# Service Bulletin No. 427

| <i>MODEL</i>      | D / J4500 Series                        | <i>TYPE</i> | Field Change Program | <i>SECTION/GROUP</i> | 1/2-Axle | <i>DATE</i> | Aug. 25, 2015 |
| <i>SUBJECT</i>    | ZF LOWER SEAL CARRIER ON KING PIN MOUNT |             |                      |                      |          |             |               |

## Important field retrofitting action: Replacement of lower seal carrier on kingpin mounting in ZF steering knuckle with ZF wheel head of the series RL 80 A/E/EM by steel version

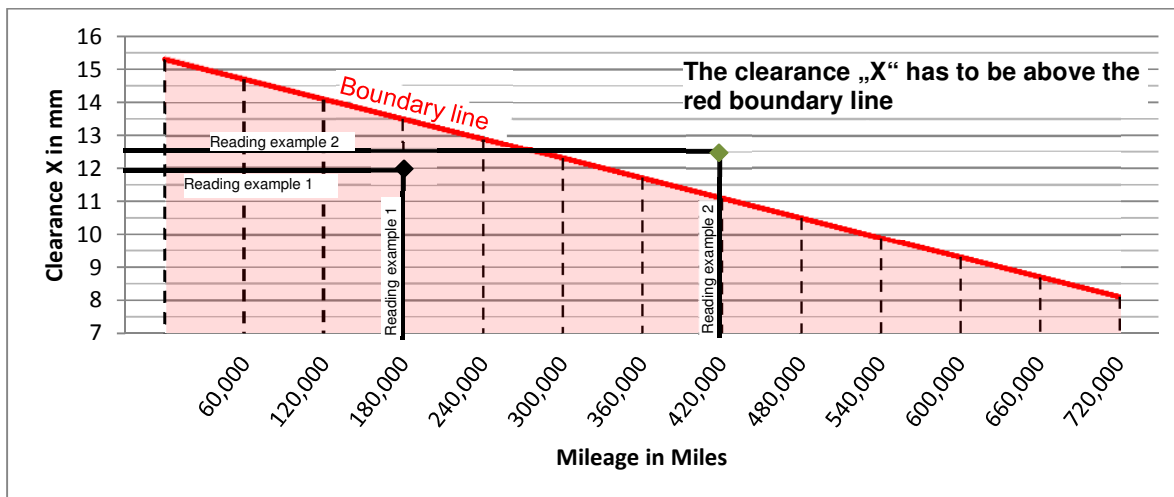
Should the mounting not be possible due to insufficient clearance between kingpin and seal carrier, the axial play should be checked acc. to ZF Service Information SI 85/11 first.

**Specified value:**  
 $\leq 1,3 \text{ mm}$

If no irregularities are found, the clearance „X“ between kingpin and bottom knuckle edge has to be checked.

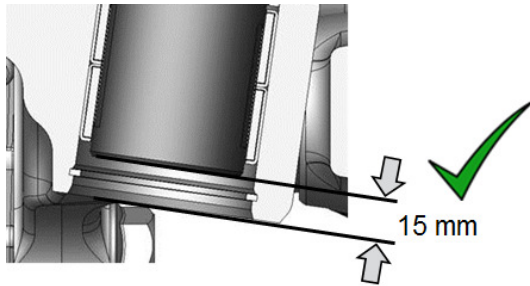
The measured clearance „X“ has to be above the red boundary line according following diagram.

**Reading example 1: Vehicle mileage 180.000 Miles / Clearance “X” 12,0 mm**

If the measured clearance “X” is below the red boundary line (acc. Reading example 1) the kingpin has to be exchanged using ZF repair kit No. 4474.298.384. It has to be assured that the axial play is below 1,3 mm (acc. RS 85/11).

In case of non-availability of ZF repair kit No. 4474.298.384, ZF repair kit 4474.298.368 has to be installed. After availability of 4474.298.384 the king pin has to be changed in a second repair.

Example clearance "X" at vehicle mileage of 180.000 Miles, validation according above diagram:

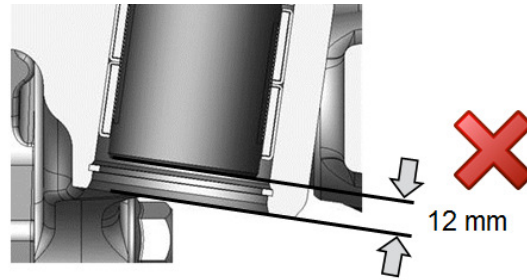
**Clearance „X“ OK  
Mount steel seal carrier**

**Clearance „X“ not OK  
Kingpin has to be exchanged**

If the measured clearance “X” is above the red boundary line (acc. Reading example 2), however the steel seal carrier cannot be mounted, the kingpin shall be pressed back into the specified position of X = 16,0 – 20,0 mm. It has to be assured that the axial play is below 1,3 mm (acc. RS 85/11).

Inspection of seal carrier and retaining ring

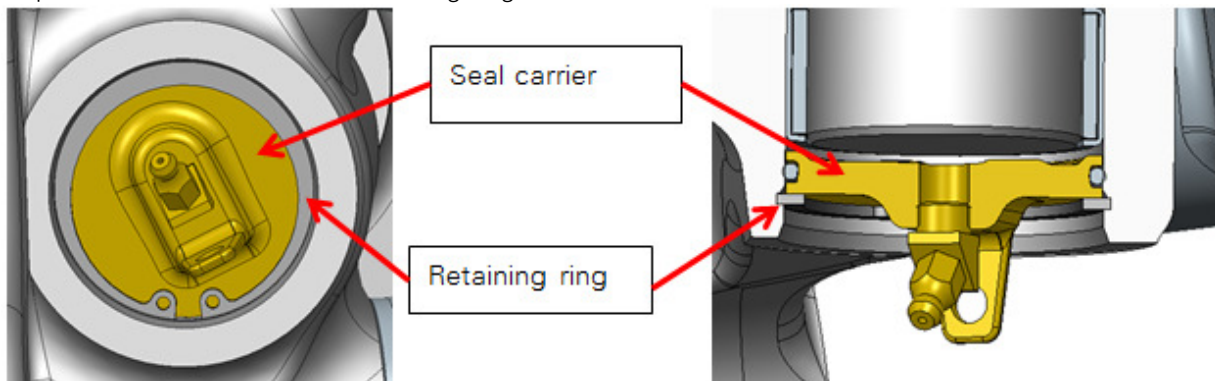
2. Visual and manual inspection of both axle sides (every 3 months / 12.000 Miles, as long as the steel seal carrier is not installed; annually / maximum 50.000 Miles after installation of steel seal carrier)

- Checking by hand whether seal carrier and grease fitting is still in position
- Cleaning of lower seal carrier and retaining ring
- Checking of lower seal carrier for damages
- Inspect seat and position of retaining ring
